Dummy Head Improvements

Informal Working Group Meeting for GTR7
In Tokyo
Feb. 3, 2010

Current GBUM Head Proposal

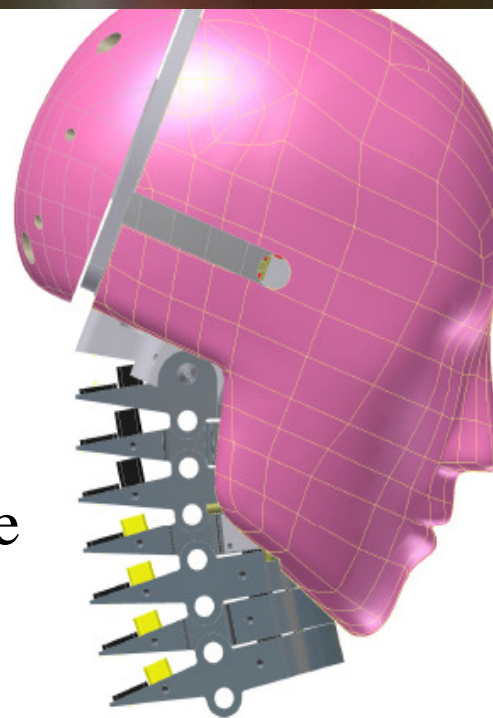
Switch

Side cable exits

Eliminate possible
C4 and chin
contacts

Feedback on GBUM Head Proposal

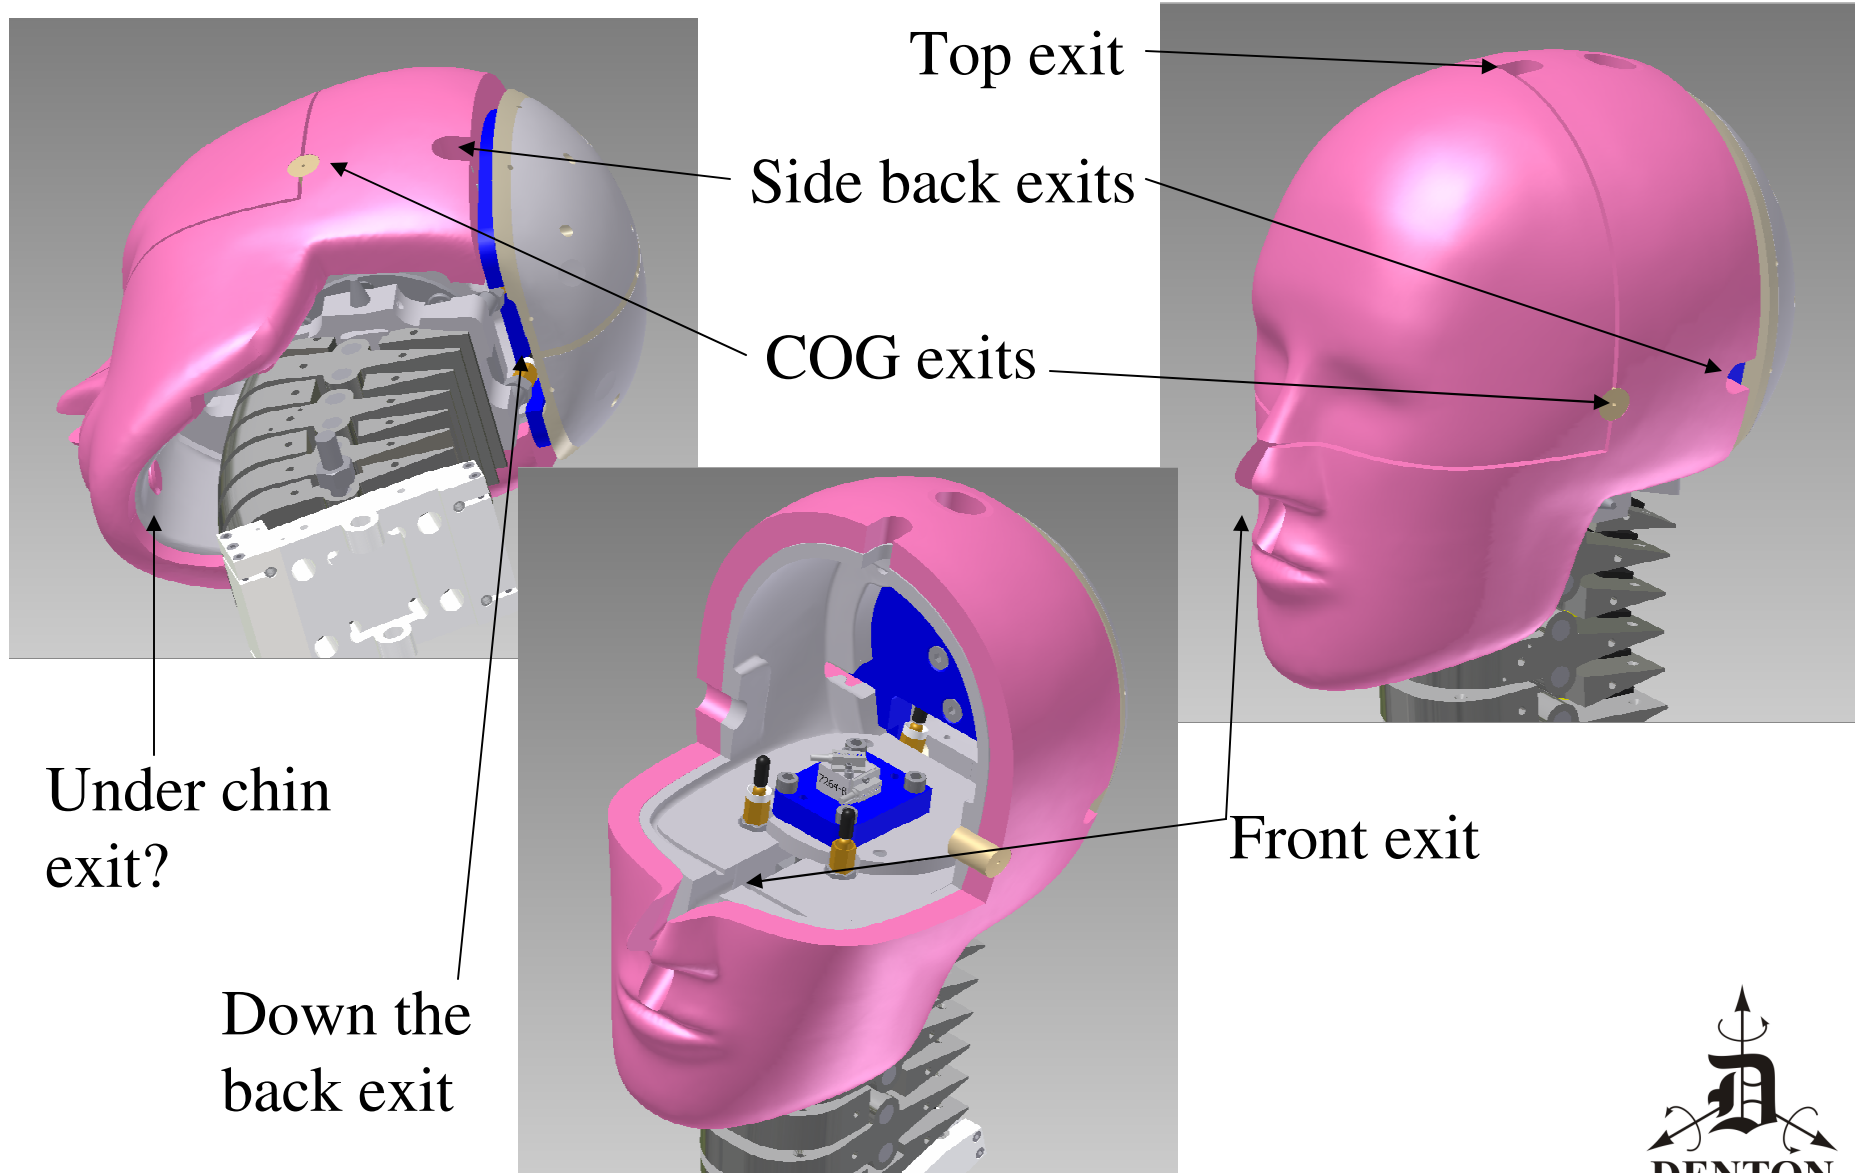
- Cap skin is softer than existing older heads
- Giving wiring options for cap switch
- Some labs are very opposed to side cable exits
- Side cable exits cause either Mz loads (one side) or interfere with video
- Switching cables side to side is nuisance
- Don't like appearance of side inserts
- Other?
